UNITED NUCLEAR
CORPORATION
CHEMICALS DIVISION

SUBJECT: SNM-33 AMENDMENT TO PERMIT BLENDING FULLY ENRICHED UO_2
WITH NATURAL ThO_2 IN THE PELLET PLANT

REFERENCE: 1) OUR LETTER OF MARCH 17, 1964 SUBJECT AS ABOVE.
2) YOUR LETTER OF DECEMBER 13, 1963 FORWARDING REQUEST
FOR ADDITIONAL INFORMATION RELATED TO RENEWAL OF SNM-33.

SCHEMATIC OF CENTERLESS
GRINDER WATER CIRCULATION
SYSTEM.

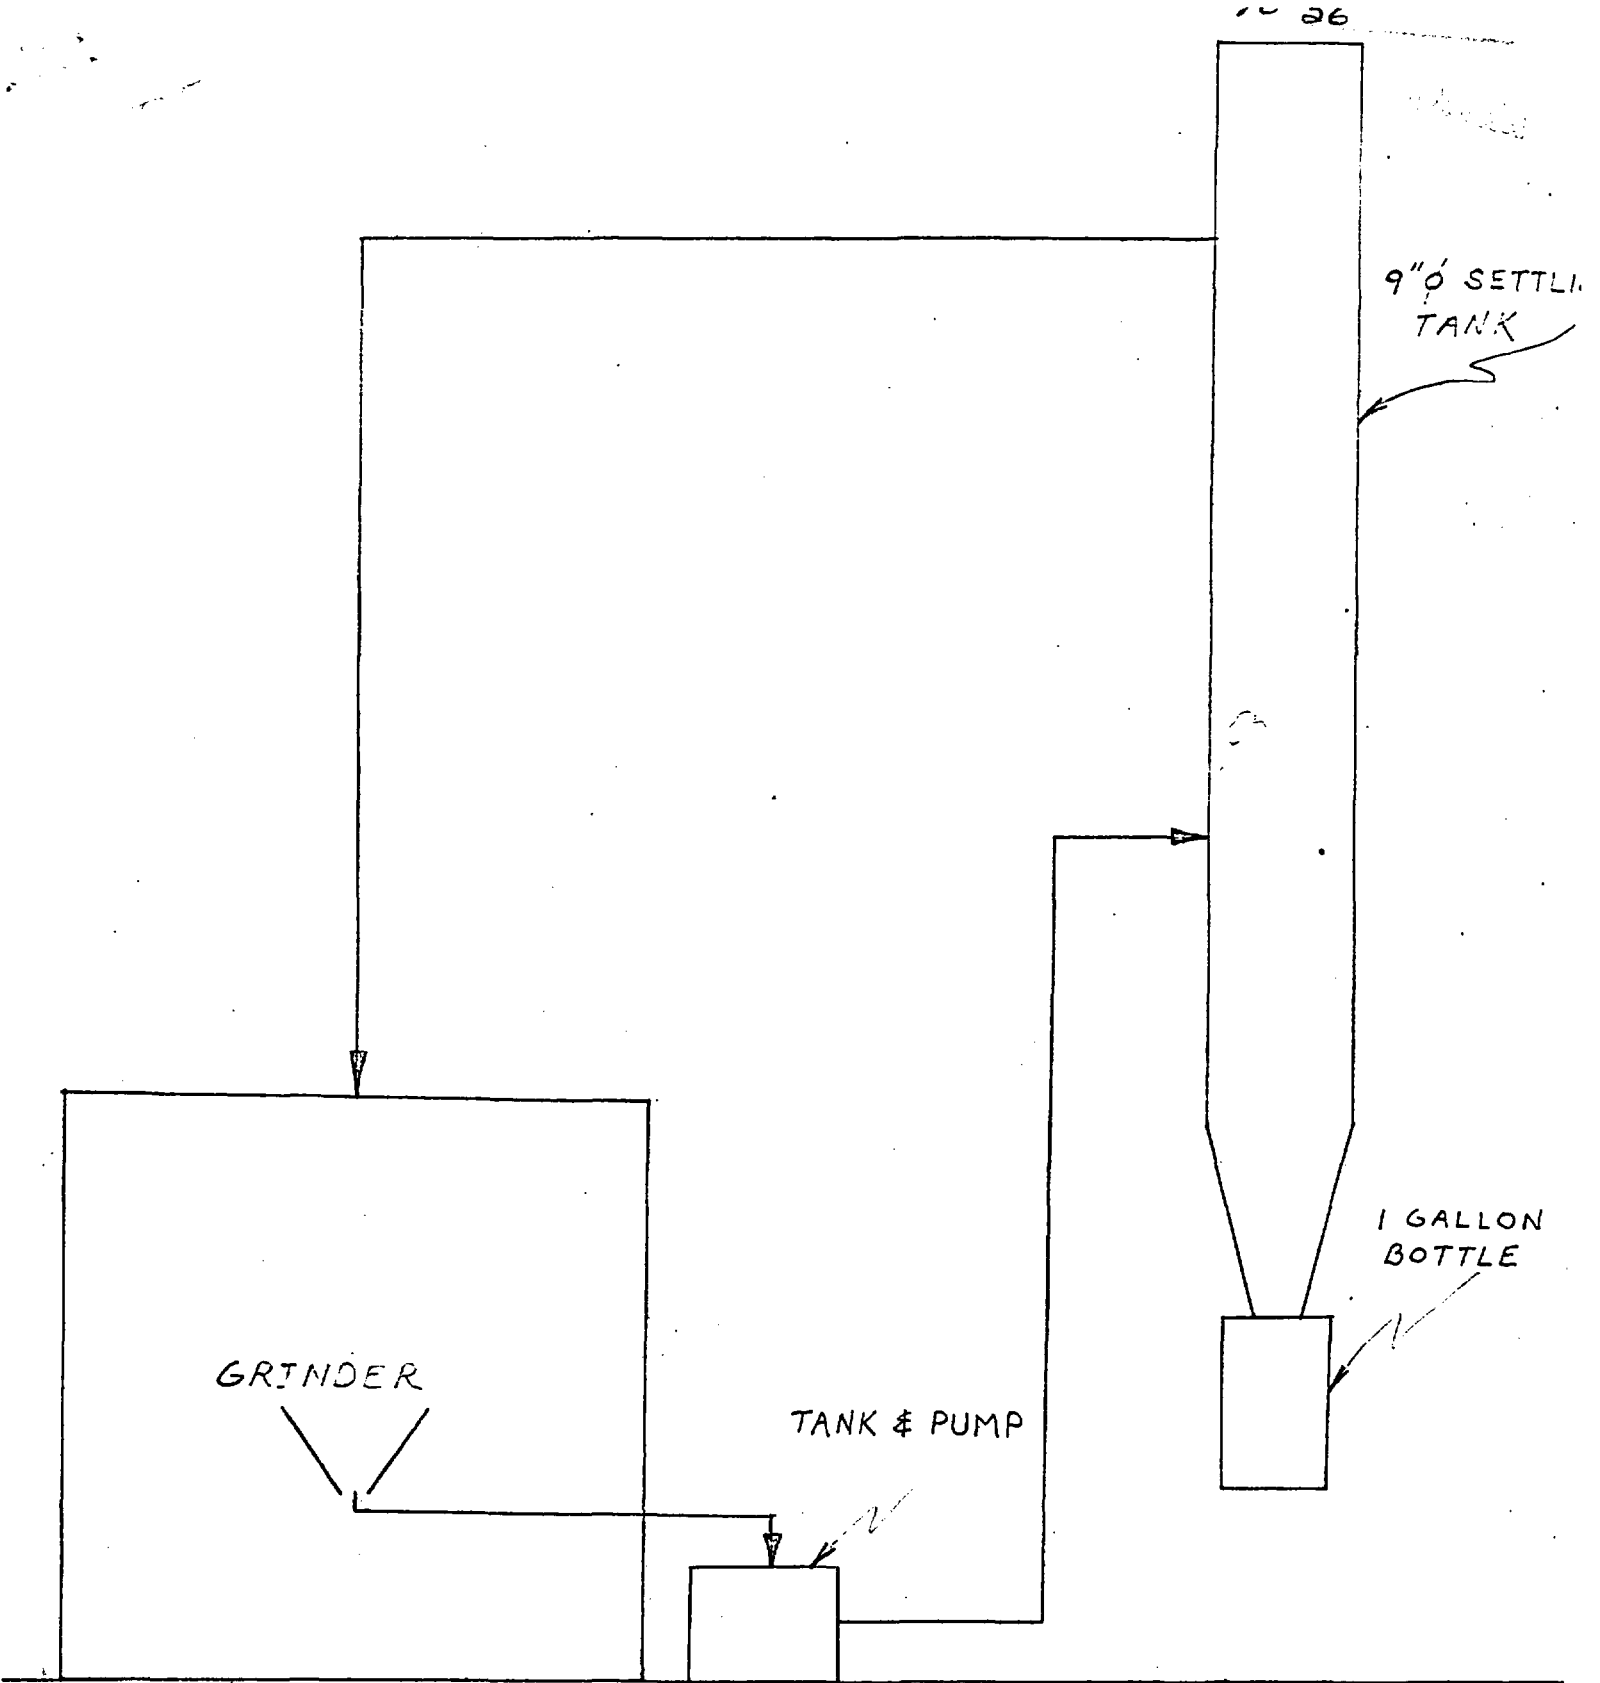
QUESTION 19 HOLDUP OF URANIUM IN CENTERLESS GRINDER (255-2-7)

WATER IS USED AS A LUBRICANT AND WASHING AGENT ON PELLETS DURING GRINDING. THE WATER CIRCULATION SYSTEM HAS BEEN MODIFIED TO BY-PASS THE SUMP IN THE GRINDER ELIMINATING HOLD UP OF WATER IN THE GRINDER. THIS IS SHOWN ON THE ATTACHED SCHEMATIC. THE SMALL TANK ASSOCIATED WITH THE PUMP IS USED TO MAINTAIN CONTINUOUS SUCTION ON THE PUMPS. AN OVERFLOW LIMITS ITS VOLUME TO 27.9 LITERS. ASSUMING A MASS OF 12.4 KG UO_2 (SAFE AT 61% ENRICHMENT) ACCUMULATED IN THIS TANK, THE UO_2 CONCENTRATION IN THE WATER WOULD BE .45 KG/LITER. THIS HIGH OF A CONCENTRATION CAN NOT BE TOLERATED IN THE GRINDING OPERATION IN ORDER TO YIELD ACCEPTABLE PELLETS.

ALSO, ONLY .002" TO .003" ARE GROUND OFF THE PELLET DIAMETER. MANY SAFE BATCHES OF PELLETS MUST PASS THROUGH THE GRINDER BEFORE EVEN A SAFE MASS IS ACCUMULATED IN THE CIRCULATION SYSTEM. THIS COUPLED WITH THE CONTINUOUS REMOVAL OF UO_2 FROM THE WATER AND THE OPERATION REQUIREMENT TO KEEP THE CONCENTRATION² BELOW 450 GRAMS/LITER INSURES THAT A SAFE MASS WILL NOT BE EXCEEDED IN THE TANK.

TO AVOID THE POSSIBILITY OF ACCUMULATION OF WHOLE OR BROKEN PELLETS IN THE GRINDER, A SCREEN IS INSTALLED UNDER THE WORK SUPPORT TO CATCH ANY PIECES OF PELLETS THAT MAY FALL OFF THE WORK SUPPORT DURING THE GRINDING PROCESS. ANY ACCUMULATION ON THIS SCREEN IS REMOVED AT THE END OF EACH SHIFT.
